TRW BUILDING AUC-1 SITE PLAN

AMENDMENTS

- ▲ ADD ATM 4-25-02
- ▲ ADD ATM SHELTER 01-08-03
- ▲ ADD PERIMETER FENCING AND PARKING LOT ACCESS CONTROL GATES 08.10.2023

NORTHROP GRUMMAN BUILDING AUC-1 PERIMETER FENCING

SHEET DESCRIPTION
SITE PLAN

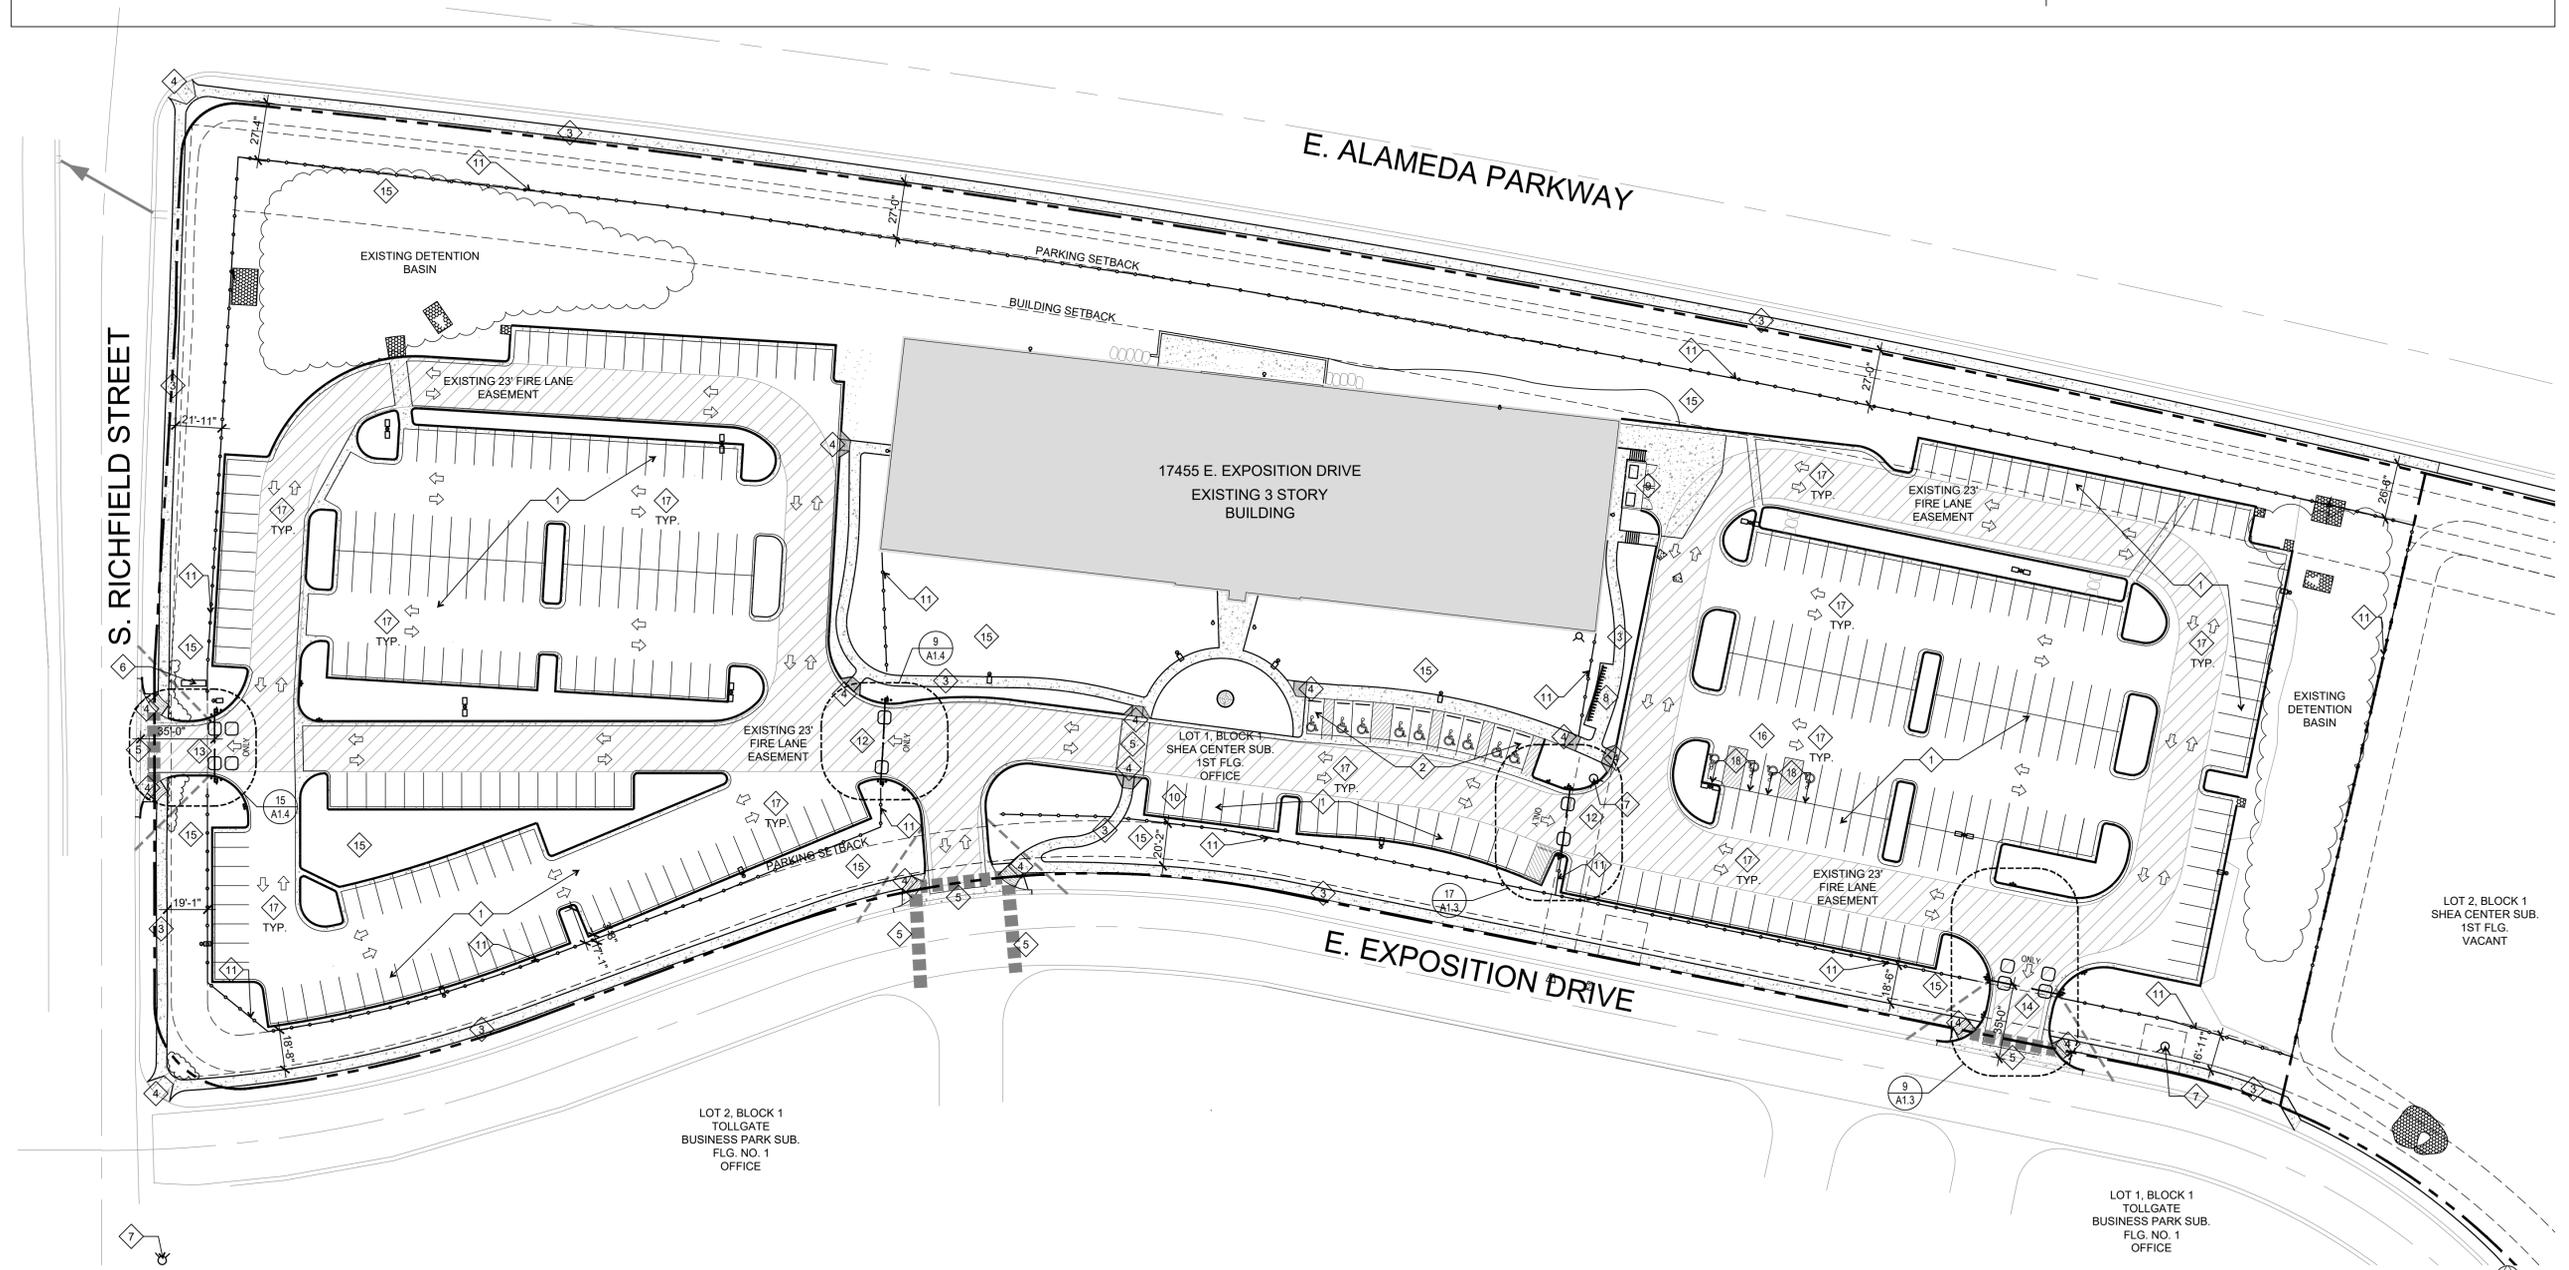
- EXISTING MOTORCYCLE PARKING SPACES.
- NEW 8'-0" DECORATIVE METAL SECURITY FENCE. SEE SHEET A1.2 FOR ADDITIONAL INFORMATION.
- (2) NEW ENTRY BARRIER ARM GATES WITH 14' AUTOMATIC BARRIER ARMS (SIMULTANEOUS VERTICAL OPENING OPERATION) AND ENTRY TERMINAL WITH BADGE READER, VOIP INTERCOM, AND OPERATOR WITH APPROVED SIREN OPERATED SENSOR, INTEGRATED KNOX BOX KEY SWITCH, AND MANUAL RELEASE. REFER TO DETAILS 3/A1.2 AND 7/A1.2. FOR ADDITIONAL INFORMATION.

- (2) NEW EXIT BARRIER ARM GATES WITH 14' AUTOMATIC BARRIER ARMS (SIMULTANEOUS VERTICAL OPENING OPERATION) WITH "FREE EXIT" LOOPS, (2) BADGE READER/VOIP INTERCOM UNITS, AND OPERATORS WITH INTEGRATED KNOX BOX KEY SWITCH, AND MANUAL RELEASE. REFER TO DETAILS 3/A1.2, 7/A1.2 AND 11/A1.2 FOR ADDITIONAL INFORMATION.

- (2) NEW ENTRY/EXIT BARRIER ARM GATES WITH 14' AUTOMATIC BARRIER ARMS (SIMULTANEOUS VERTICAL OPENING OPERATION) WITH "FREE EXIT" LOOPS, (2) BADGE READER/VOIP INTERCOM UNITS, SEPARATE VOIP INTERCOM AND OPERATORS WITH INTEGRATED KNOX BOX KEY SWITCH, AND MANUAL RELEASE REFER TO DETAILS 3/A1.2, 7/A1.2 AND 11/A1.2 FOR ADDITIONAL INFORMATION.

17 ENLARGED VEHICLE ENTRY PLAN
SCALE: 1/8"=1'-0"

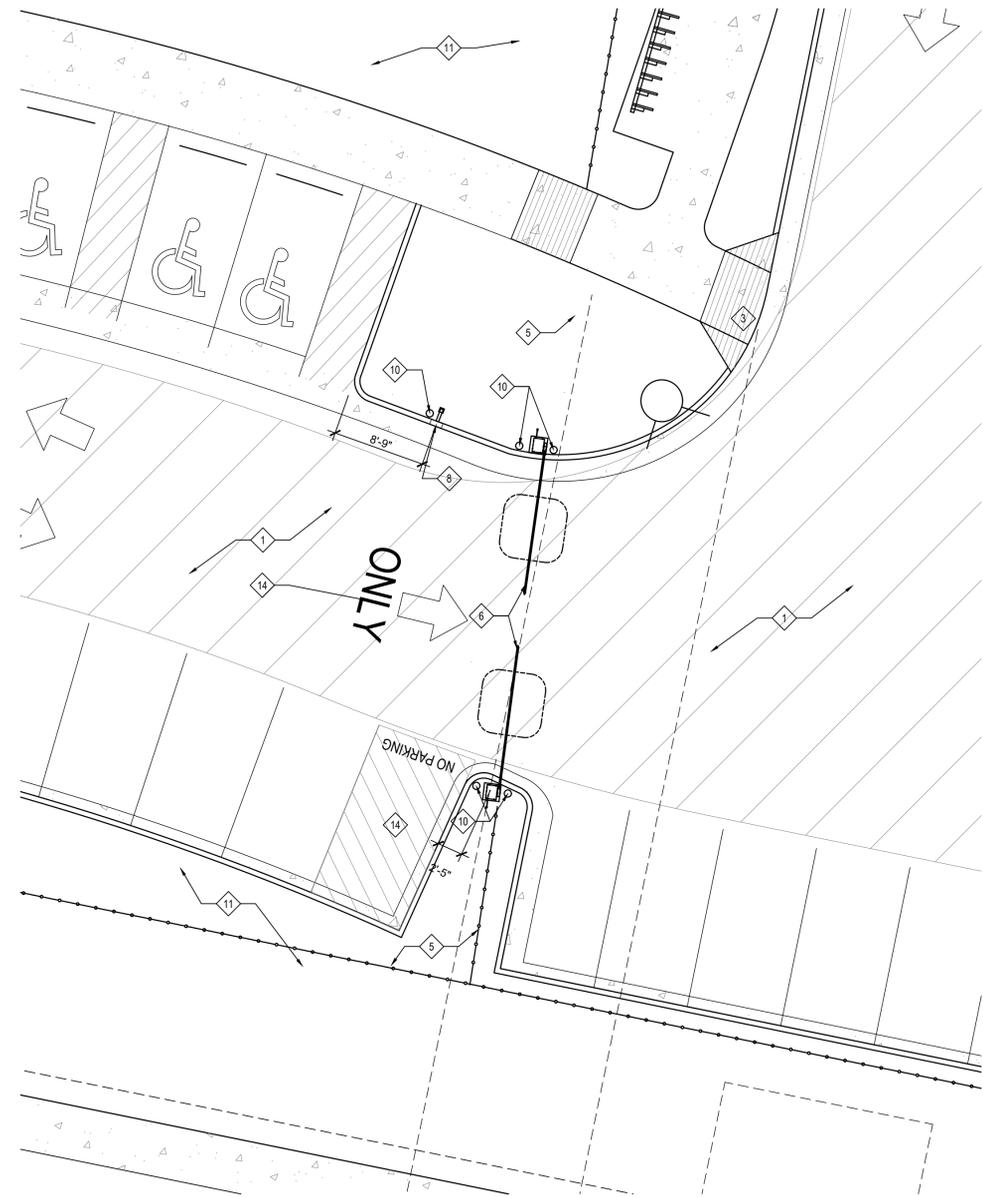
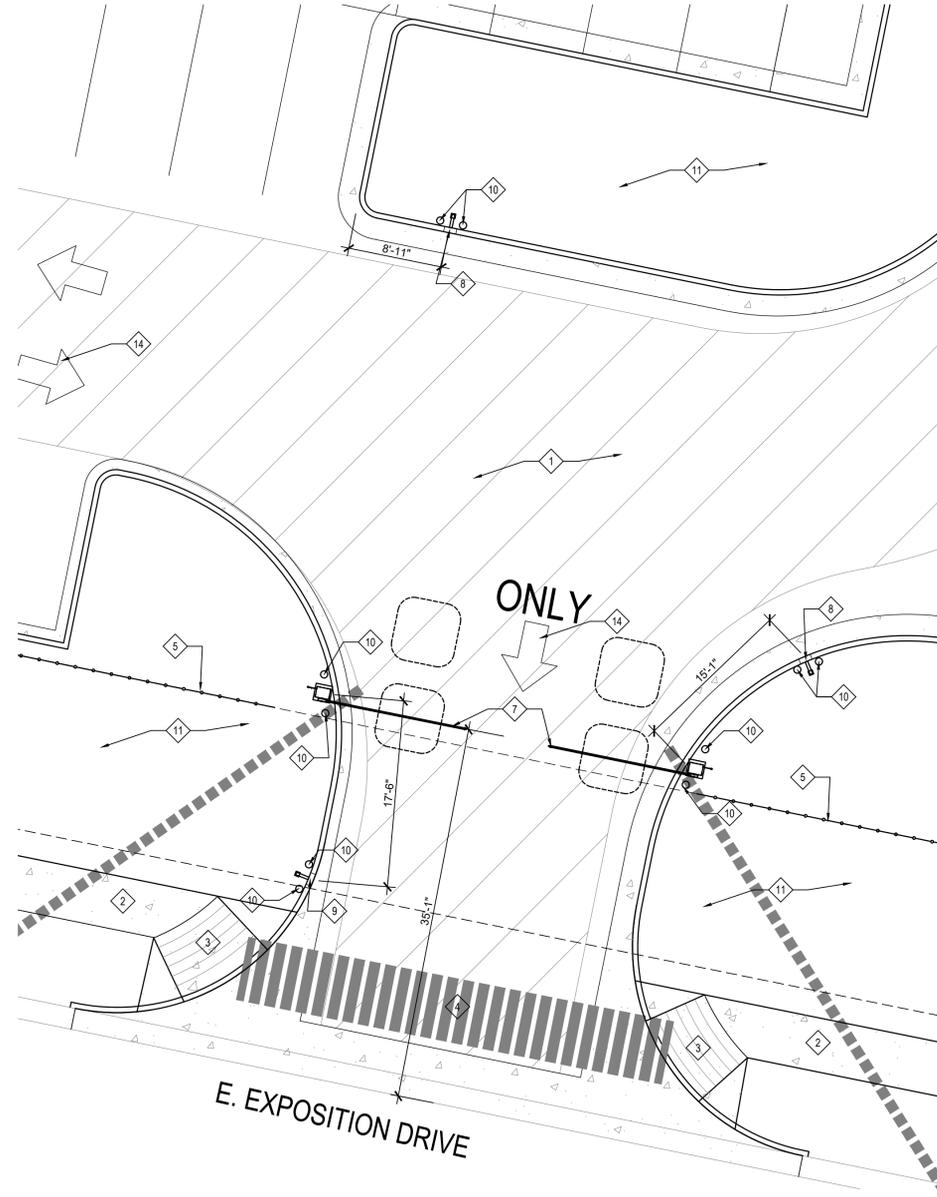
1. EXISTING PARKING LOT / SITE LIGHTING TO REMAIN.
2. EXISTING SIDEWALKS TO REMAIN.
3. EXISTING CURB RAMP TO REMAIN.
4. EXISTING CROSSWALK TO REMAIN.
5. NEW 8'-0" DECORATIVE METAL SECURITY FENCE EQUAL TO AMERISTAR MONTAGE COMMERCIAL CLASSIC PROVIDED AND INSTALLED BY G.C. SEE 5/A1.2 FOR FENCE AND GATE DETAILS.

6. (2) NEW ENTRY BARRIER ARM GATES WITH 14' AUTOMATIC BARRIER ARMS (SIMULTANEOUS VERTICAL OPENING OPERATION) AND PRIMARY AND SECONDARY OPERATORS WITH APPROVED SIREN OPERATED SENSOR, INTEGRATED KNOX BOX KEY SWITCH AND MANUAL RELEASE EQUAL TO HYSECURITY STRONG ARM PARK DC 14. BARRIER GATE, OPERATORS AND VEHICLE DETECTION LOOP PROVIDED AND INSTALLED BY G.C. REFER TO DETAILS 3/A1.2 AND 7/A1.2. FOR ADDITIONAL INFORMATION.

7. (2) NEW ENTRY / EXIT BARRIER ARM GATES WITH 14' AUTOMATIC BARRIER ARMS (SIMULTANEOUS VERTICAL OPENING OPERATION) AND OPERATORS WITH INTEGRATED KNOX BOX KEY SWITCH AND MANUAL RELEASE EQUAL TO HYSECURITY STRONG ARM PARK DC 14. BARRIER GATE OPERATORS, "FREE EXIT" LOOP AND VEHICLE DETECTION LOOP PROVIDED AND INSTALLED BY G.C. REFER TO DETAILS 3/A1.2 AND 7/A1.2. FOR ADDITIONAL INFORMATION.

8. NEW CARD READER / INTERCOM AND GOOSENECK PEDESTAL PROVIDED AND INSTALLED BY TENANT. CONCRETE PAD AND SETTING BOLTS PROVIDED AND INSTALLED BY G.C. AS DIRECTED BY TENANT. CONDUIT BACK TO SECURITY OFFICE IN MAIN BUILDING BY G.C.

9. VOIP INTERCOM FOR REQUEST TO ENTER AND GOOSENECK PEDESTAL PROVIDED AND INSTALLED BY TENANT. CONCRETE PAD AND SETTING BOLTS PROVIDED AND INSTALLED BY G.C. AS DIRECTED BY TENANT. CONDUIT BACK TO SECURITY OFFICE IN MAIN BUILDING BY G.C.

10. 8" Ø CONCRETE FILLED PAINTED PIPE BOLLARD PROVIDED AND INSTALLED BY G.C. REFER TO DETAILS 15/A1.2 AND 19/A1.2 FOR ADDITIONAL INFORMATION
11. EXISTING LANDSCAPING TO REMAIN UNDISTURBED EXCEPT WHERE EXISTING INTERFERES WITH INSTALLATION OF FENCE OR ENTRY / EXIT GATES. REPLACE EXISTING DISTURBED LANDSCAPING WITH NEW AND INSTALL NEW LANDSCAPING TO MATCH CITY OF AURORA REQUIREMENTS FOR PARKING LOT SCREENING. SEE LANDSCAPE DRAWINGS FOR ADDITIONAL INFORMATION.

15 ENLARGED VEHICLE EXIT PLAN
SCALE: 1/8"=1'-0"

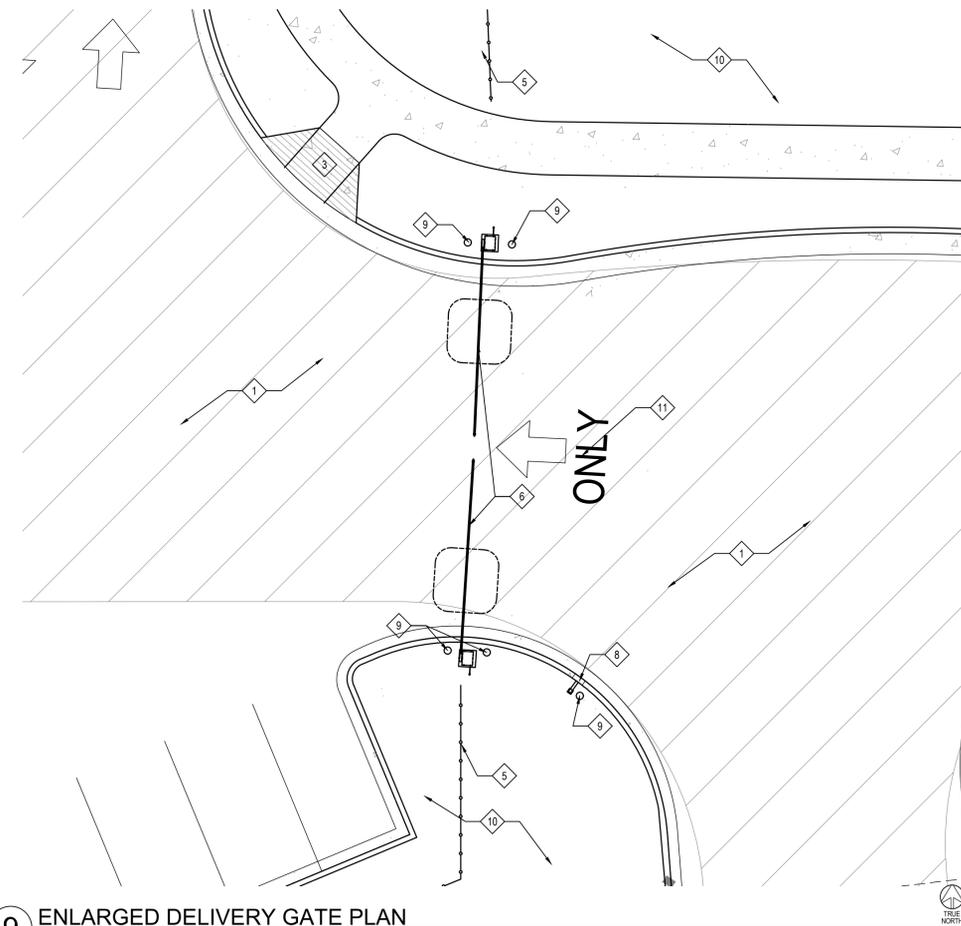
5. NEW 8'-0" DECORATIVE METAL SECURITY FENCE EQUAL TO AMERISTAR MONTAGE COMMERCIAL CLASSIC PROVIDED AND INSTALLED BY G.C. SEE 5/A1.2 FOR FENCE AND GATE DETAILS.

6. (2) NEW ENTRY BARRIER ARM GATES WITH 14' AUTOMATIC BARRIER ARMS (SIMULTANEOUS VERTICAL OPENING OPERATION) AND PRIMARY AND SECONDARY OPERATORS WITH APPROVED SIREN OPERATED SENSOR, INTEGRATED KNOX BOX KEY SWITCH AND MANUAL RELEASE EQUAL TO HYSECURITY STRONG ARM PARK DC 14. BARRIER GATE, OPERATORS AND VEHICLE DETECTION LOOP PROVIDED AND INSTALLED BY G.C. REFER TO DETAILS 3/A1.2 AND 7/A1.2 FOR ADDITIONAL INFORMATION.

7. (2) NEW EXIT BARRIER ARM GATES WITH 14' AUTOMATIC BARRIER ARMS (SIMULTANEOUS VERTICAL OPENING OPERATION) WITH "FREE EXIT" LOOP AND PRIMARY AND SECONDARY OPERATORS WITH INTEGRATED KNOX BOX KEY SWITCH, AND MANUAL RELEASE EQUAL TO HYSECURITY STRONG ARM PARK DC 14. BARRIER GATE OPERATORS, "FREE EXIT" LOOP, AND VEHICLE DETECTION LOOP PROVIDED AND INSTALLED BY G.C. REFER TO DETAILS 3/A1.2 AND 11/A1.2 FOR ADDITIONAL INFORMATION.

8. NEW CARD READER / INTERCOM AND GOOSENECK PEDESTAL PROVIDED AND INSTALLED BY TENANT. CONCRETE PAD AND SETTING BOLTS PROVIDED AND INSTALLED BY G.C. AS DIRECTED BY TENANT. CONDUIT BACK TO SECURITY OFFICE IN MAIN BUILDING BY G.C.

9. 8" Ø CONCRETE FILLED PAINTED PIPE BOLLARD PROVIDED AND INSTALLED BY G.C. REFER TO DETAILS 15/A1.2 AND 19/A1.2 FOR ADDITIONAL INFORMATION
10. EXISTING LANDSCAPING TO REMAIN UNDISTURBED EXCEPT WHERE EXISTING INTERFERES WITH INSTALLATION OF FENCE OR ENTRY / EXIT GATES. REPLACE EXISTING DISTURBED LANDSCAPING WITH NEW AND INSTALL NEW LANDSCAPING TO MATCH CITY OF AURORA REQUIREMENTS FOR PARKING LOT SCREENING. SEE LANDSCAPE DRAWINGS FOR ADDITIONAL INFORMATION.
